The Sizewell C Project

6.16 Ch Second Environmental Statement Addendum
Volume 1: Second Environmental Statement Addendum
Chapters
Chapter 3: Two Village Bypass

Revision: 1.0
Applicable Regulation: Regulation 5(2)(q)
PINS Reference Number: EN010012

July 2021

Plate 3.1 Proposed change at Friday Street roundabout

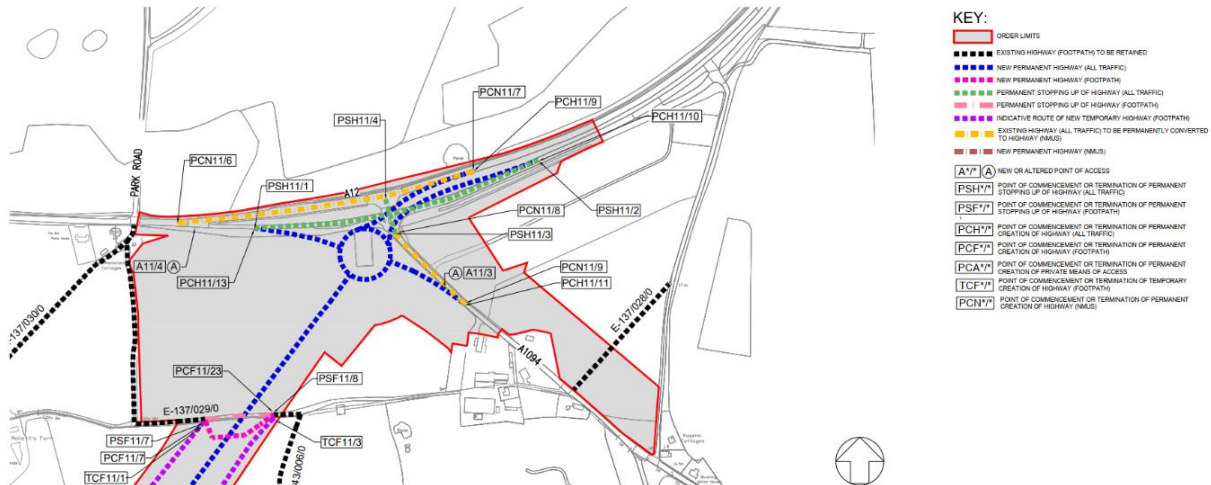
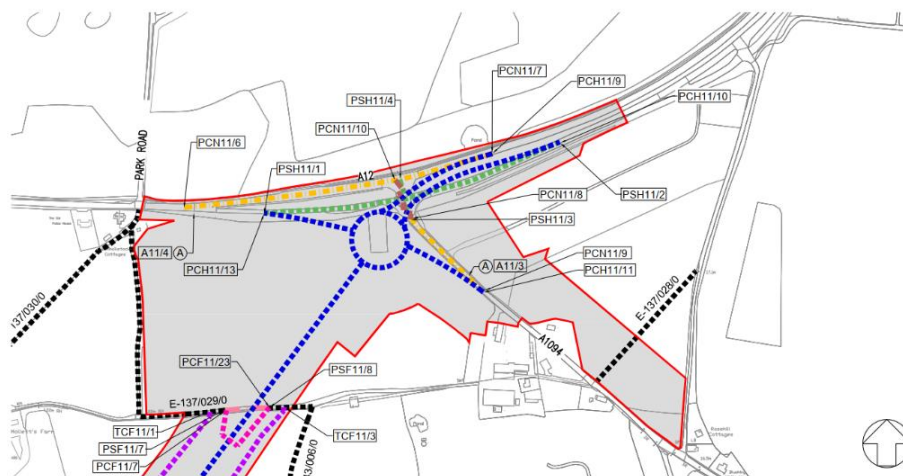
3.2.21 Between points PSH11/4 and A11/3 the **Access and Rights of Way Plans** (Doc Ref. 2.4(D)), and shown on Plate 3.1, the dotted green line signifies the 'permanent stopping up of highway (all traffic)'.

3.2.22 SZC Co. proposes to create a crossing at the north-eastern arm of the proposed Friday Street roundabout (across the tie-ins with the existing A12

towards Saxmundham). The proposed crossing would provide a link for non-motorised use (i.e. pedestrians, cyclists, equestrians) between the ‘old’ A12 and the ‘old’ A1094.

The change to provide a connection between the non-motorised user routes is proposed in response to feedback from the owners of Friday Street Farm and through discussions with SCC and ESC. The proposed change would allow for pedestrian, cycle and equestrian access between the proposed non-motorised user routes and provide safe access between Farnham and Friday Street Farm by foot or bicycle. It would also assist in non-motorised users travelling to/from Farnham connecting with footpath E-137/028/0 off

the A1094 and help to alleviate a concern raised by SCC regarding cyclists using the Friday Street roundabout.
